Item Name: Energy Attenuating Floor Provisions

DART SERVICE INSTRUCTION

TO AMEND INSTALLATION INSTRUCTIONS IIN-D350-689 REV. B AND INSTRUCTIONS FOR CONTINUED AIRWORTHINESS ICA-D350-689 REV. 1

B	CHANGES TO -013 KIT INSTALLATION. REF: CIR12-12.	MB	12.11.09
A	NEW ISSUE	MB	11.12.22
REV.	DESCRIPTION	BY	DATE
DESIGN		DART AEROSPACE LTD	
DRAWN		HAWKESBURY, ONTARIO, CANADA	
CHECKED		DRAWING NO.	REV. B
MFG. APPR.	N/A	DSI 9588	SHEET 1 OF 6
APPROVED		TITLE	SCALE
DE APPR.		INSTALLATION CHANGE	NTS
DATE	12.11.09	COPYRIGHT © 2011 BY DART AEROSPACE LTD THIS DOCUMENT IS PRIVATE AND CONFIDENTIAL AND IS SUPPLIED ON THE EXPRESS CONDITION THAT IT IS NOT TO BE USED FOR ANY PURPOSE OR COPIED OR COMMUNICATED TO ANY OTHER PERSON WITHOUT WRITTEN PERMISSION FROM DART AEROSPACE LTD.

FIGURE 1: UPDATES TO CROSS SECTIONS F-F AND M-M
 With reference to Figures 5 and 7 of IIN-D350-689
 (Figures 25-5 and 25-7 of ICA-D350-689)

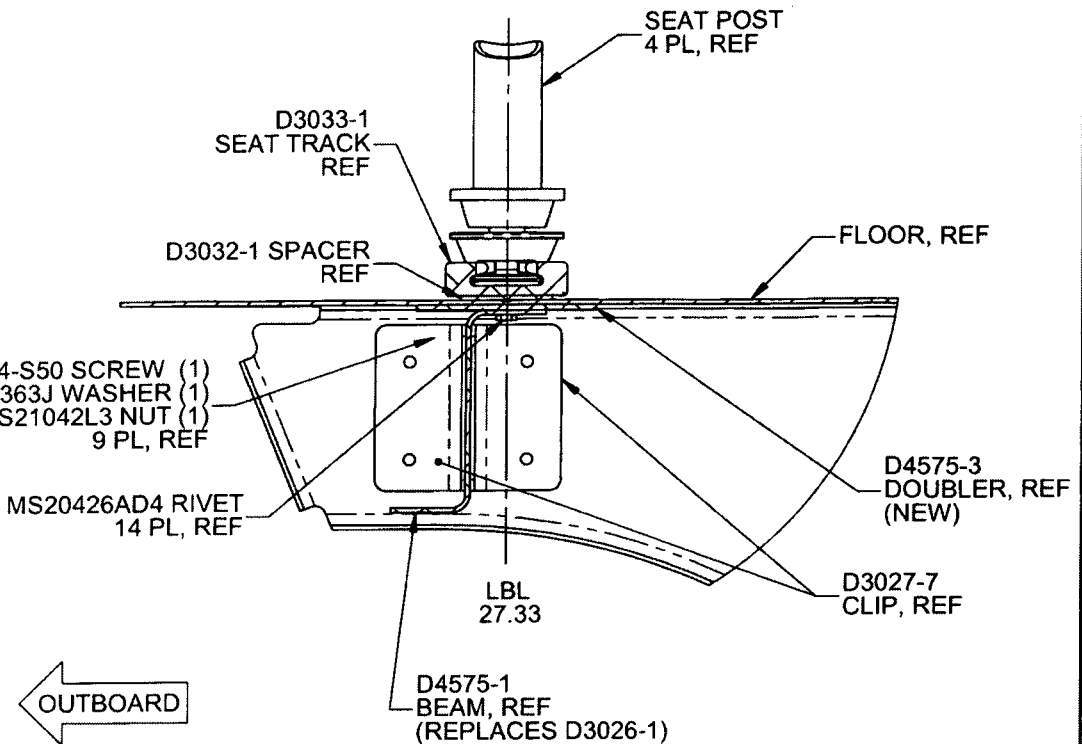
For D350-689-011/-013 at CHG 006/005 and later and D350-689-021/-023 Kits at CHG 005/004 and later, the D3026-1 Channel has been replaced with the D4575-1 Beam and D4575-3 Doubler and the D3234-3 Doubler has been removed. Consequently, the installation instructions for D350-689-011/-013 at CHG 006/005 and D350-689-021/-023 at CHG 005/004 are updated per Section 2.0 of this Service Instruction. The parts list update is shown in Section 4.0 of this Service Instruction. There is a negligible change to the weight and balance.

If there is an existing stringer at LBL 27.33, it will need to be removed from that location. Locate D4575-1 Beam, D4575-3 Doubler, and D3032-1 Spacer as shown in Figure 1 of this Service Instruction. Transfer drill existing holes from the aircraft floor to the D4575-1 Beam, D4575-3 Doubler, and D3032-1 Spacer. Ensure 1.0" to 1.5" rivet pitch and add additional holes if required. If there is no existing stringer, locate D4575-1 Beam, D4575-3 Doubler, and D3032-1 Spacer as shown in Figure 1 of this Service Instruction and drill Ø0.128" holes on a 1.0" to 1.5" pitch.

If there is an existing stringer at LBL 27.33, it will need to be removed from that location. Locate D4575-1 Beam and D4575-3 Doubler as shown in Figure 2 of this Service Instruction. Transfer drill existing holes from the aircraft floor to the D4575-1 Beam and D4575-3 Doubler. Ensure 1.0" to 1.5" rivet pitch and add additional holes if required. If there is no existing stringer, locate D4575-1 Beam and D4575-3 Doubler as shown in Figure 1 of this Service Instruction and drill Ø0.128" holes on a 1.0" to 1.5" pitch.

FIGURE 3: RELIEFS ON D4575-1/-3
(ONLY D4575-1/-3 SHOWN FOR CLARITY)
VIEW LOOKING INBOARD

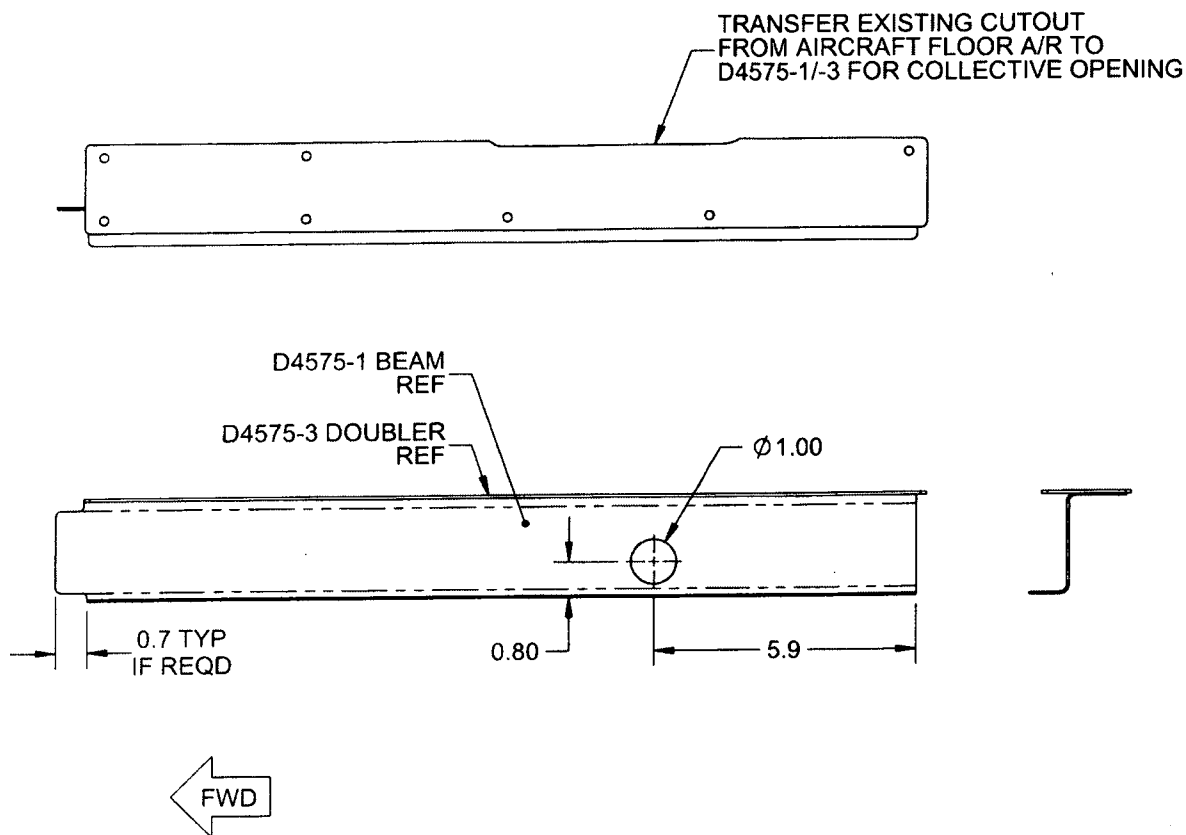
Note: Drill a Ø1.00" (Ø25.4 mm) hole in the D4575-1 Beam to clear extension tube of collective and cutout as required for clearance of collective opening and fwd bulkhead as shown in Figure 3 of this Service Instruction.

Note: Drill a Ø1.00" (Ø25.4 mm) hole in the D4575-1 Beam to clear extension tube of collective and cutout as required for clearance of collective opening and fwd bulkhead as shown in Figure 3 of this Service Instruction.
